Interactive comment on “Evaluation of the IAGOS-Core GHG Package H₂O measurements during the DENCHAR airborne inter-comparison campaign in 2011” by Annette Filges et al.

Author's response to Interactive comment by Anonymous Referee #1 on “Evaluation of the IAGOS-Core GHG Package H₂O measurements during the DENCHAR airborne inter-comparison campaign in 2011” by Annette Filges et al.

Fig. 1. fig03_dew point mirror calibration

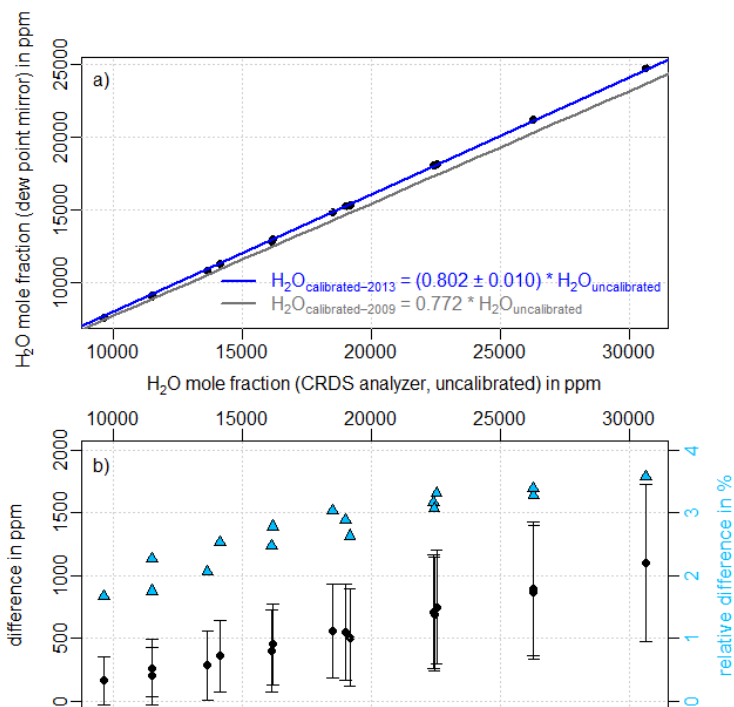
16) Pg 10, L12-14, L20: The differences between calibration curves presented in ppm in Figures 3b and 4b and expressed in ppm and % (rel) in the text may cause confusion here. If you express all mixing ratios, differences and residuals in ppm it avoids any confusion. For the Figures 3b and 4b it would add value to include a right axis of relative differences/residuals. Given the near-linearity of the differences/residuals against mixing ratios, I think the relative data (different symbol/color) would be quite constant over the entire range of mixing ratios.

A right axis of relative differences/residuals was added in Figures 3b and 4b.

Added in Section 3.2.1, page 10 line 5: "The relative difference of the two calibrations, shown on the right axis, increases ..."

Added in Caption of Figure 3: "... calibration. The relative differences are plotted on the right axis as light blue triangles."

Fig. 3. fig05_FishCalBench calibration

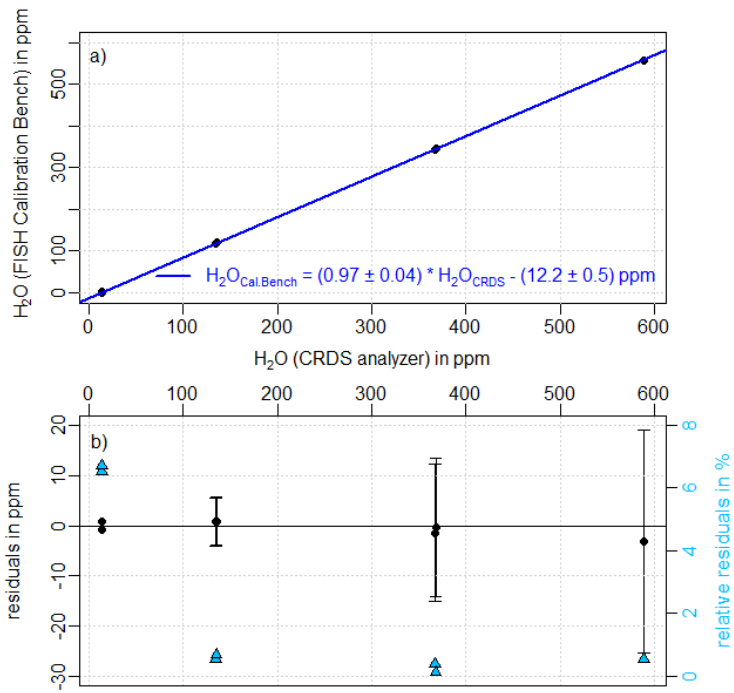
19) Pg 11, L5-13 and Figure 5: The residuals in Figure 5b (presented in ppm) are discussed in the text in relative (%) terms. Adding a right axis for relative residuals to Figure 5b (using different symbol/color) would strengthen the discussion of relative residuals in the text.

A right axis of relative differences/residuals was added in Figures 5b.

Added in Section 3.2.2, page 11 line 8-10: "... residuals ... for water vapors > 100 ppm, which can be seen in plot (b), are small compared to the uncertainty range of the FISH calibration bench of 4 % indicated by the error bars. For the measurement point at 2 ppm water vapor the relative residuals are larger (6.2 %), due to the influence of the 12.2 ppm offset.

Added in Caption of Figure 5: "... of 4 %. The relative residuals are plotted on the right axis as light blue triangles."

Fig. 4. fig06_dilution calibration

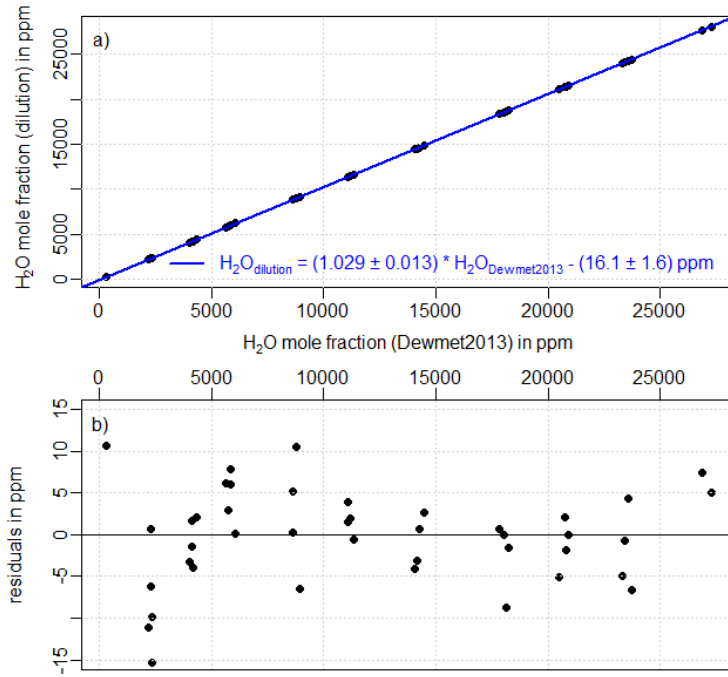
20) Pg 11, L30-31: It is odd that the residuals at 250 ppm are negative (Figure 6b) while at the lowest mixing ratio they are positive. With an offset of 16 ppm one would expect the residuals at both of the lowest mixing ratios to be of the same sign. Any idea why they are negative at 250 ppm and positive at the lowest mixing ratio?

21) Pg 12, L1: If "the lowest measurement was made at around 300 ppm", why are there data points below 300 ppm in Figure 6?

The residuals are negative at 2500 ppm, not 250 ppm, and positive at 300 ppm. Unfortunately there is only one data point at 300 ppm. With more measurements at this water vapor level we would expect the scatter/pattern of the residuals to be similar to

the ones at other water vapor levels. Therefore, as described in Section 3.2.3, the uncertainty range of 1.6 ppm of the offset is likely unrealistic and follow on experiments should contain more measurements at low water vapor levels (<300 ppm).

There are no data points below 300 ppm. 1 % water vapor mole fraction corresponds to 10000 ppm, not 1000 ppm. For clarification all water vapor values were changed to ppm in the text and figures.

Fig. 5. fig07_measurement precision

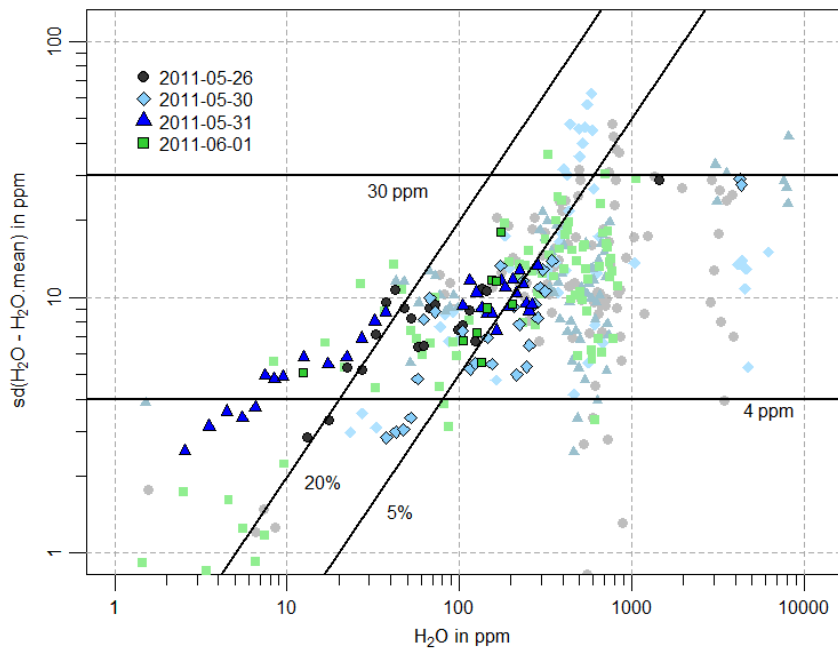
General Comments 1) I don't agree with the measurement "repeatability" values determined in this paper for WV mixing ratios <100 ppm. On page 14 it is stated that an "upper limit for the measurement repeatability" .. is : : : "4 ppm or 5%, whichever is

greater for WV < 100 ppm". If that is the case, why are there so many data points for WV < 100 ppm in Figure 7 that have standard deviations > 5 ppm (5%)? The upper limit estimate for WV > 100 ppm is much more in line with the Figure 7 data.

33) Pg 14, L26-27: "upper limit" ... "4 ppm or 5%, whichever is greater for WV < 100 ppm". In Figure 7, why are there so many data points for WV < 80 ppm that have standard deviations > 4 ppm (5%)? The upper limit estimate for WV > 100 ppm is much more in line with the Figure 7 data: most of the data points for WV > 100 ppm lie below the 30 ppm standard deviation line and to the right of the 5% diagonal. This cannot be said about the WV < 100 ppm data, many of which lie above the 4 ppm standard deviation line and to the left of the 5% diagonal. Please explain the connection between this Figure and the numbers you have extracted from it that appear to underestimate the precision values for measurements at WV < 100 ppm.

Measurement repeatability values were revised. The new estimates are 4 ppm for H₂O <10 ppm, 20 % or 10 ppm (whichever is smaller) for 10 ppm < H₂O <100 ppm, and 5 % or 30 ppm (whichever is smaller) for H₂O >100 ppm

Added in Figure 7: line indicating a standard deviation of 20 %

Added in caption of Figure 7, line 6: "... of 4 and 30 ppm, and 5 and 20 % respectively."

Fig. 6. fig08_response time wet-dry

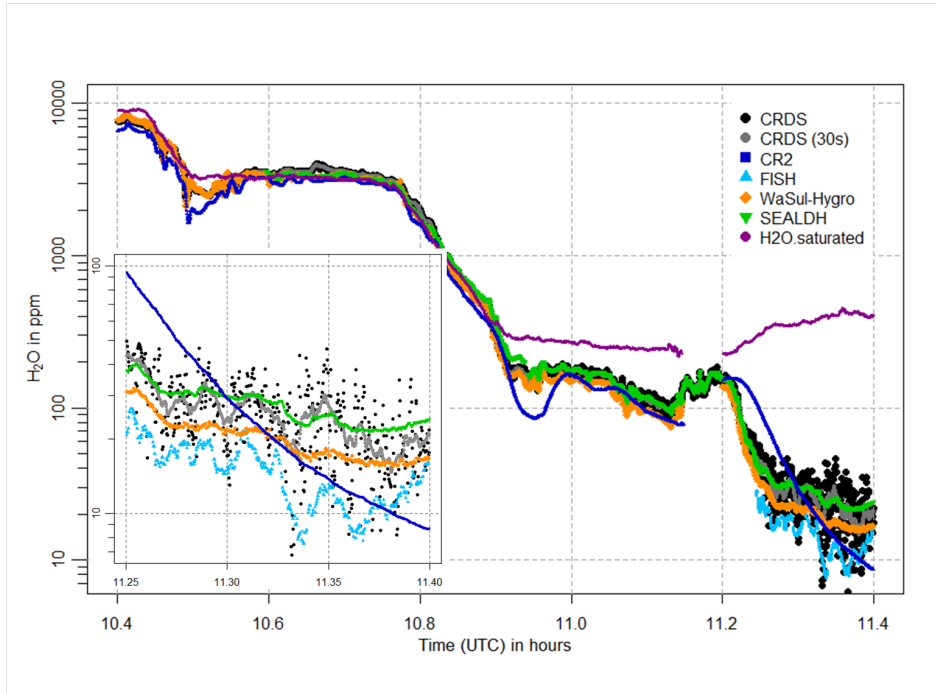
34) Pg 15, L9-16: No need to describe the different symbols since that is done in both the Figure 8 caption and legend. What is more important here is a description of what the Figure shows about response time of the CRDS. I think that showing only a short period of Figure 9 would better support this discussion of response times <10 seconds. Specifically, the flight segment from 12.35 to 12.55 UTC on 1 June 2011 when water vapor increases and falls an order of magnitude in about 3 minutes.

Enlarged sections for selected shorter time periods are added in Figure 8 and 9.

Added in Caption of Figure 8: "... flight on 31 May 2011. An enlarged section for the time period from 11:15 to 11:24 is shown in the lower left part of the plot."

Added in Section 4.1.2, page 15 line 19: "... to wet. For water vapors <100 ppm the response time is comparable to the FISH instrument, as shown in the enlarged section of Fig. 8. During the increase of water vapor from 200 to 1200 ppm in about one minute, shown in the enlarged section in Figure 9, no significant delay can be detected. Thus, ..."

Fig. 8. fig11_absolute differences_all flights

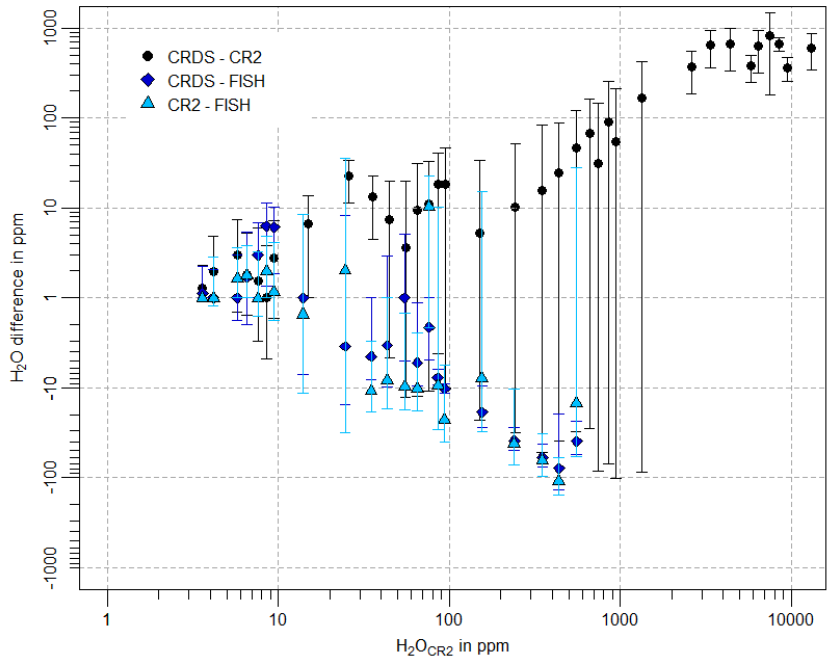
36) Pg 15, L27-31 and Pg 16 L1-6: Please remove Figure 11 symbol descriptions and the explanation of data binning since all this information appears in the Figure caption.

37) Pg 16, L1-2 and Figure 11 caption: "Absolute" differences steers my thinking towards absolute values, which are definitely not what Figure 10 shows. "Absolute" is unnecessary in both instances because the differences are clearly in units of ppm, i.e., not relative differences.

38) Pg 16, L4-6 and Figure 11: If the differences are binned by CR-2 water vapor in 1 ppm bins for CR-2 < 10 ppm, why are there multiple blue diamonds and multiple blue triangles in the lowest CR-2 mixing ratio bin (and some other bins)? Aren't the averages computed from all segments of all flights? If not, why are the average differences in each bin determined for subsets of the 4 flights?

39) Figure 11: The log-scale Y-axis is problematic for average differences < 1 ppm and for the error bars that appear asymmetric around the mean. Why don't you instead plot average relative (%) differences using a linear-scale Y axis? Average differences < 1 ppm will then be displayed correctly and the error bars will be symmetric around the mean values. I think the relative values will be much more like flat lines with CRDS-CR2 values above zero and the other instrument pairs below zero.

Added in caption of Figure 11: "... differences. The water vapor measurements of CR-2 are chosen as x-axis, because they cover all flights in contrast to the FISH data. For plotting reasons all differences <1 ppm are set to 1 ppm."

Changed in Figure 11, caption: "Differences ..."

Figure 11 was corrected. Now there is only one data point for each bin.

We plotted the relative differences using a linear axis, too. The problem with this display

is that for water vapors <100 ppm, and especially <10 ppm, the relative differences are very large (up to 50-100 %). For the interpretation of the results at <100 ppm a plot with differences in ppm is much clearer and easier to understand. So, both representations have their pros and cons. In the end we decided that the plot with the log-scales is a bit better suited for our purposes.
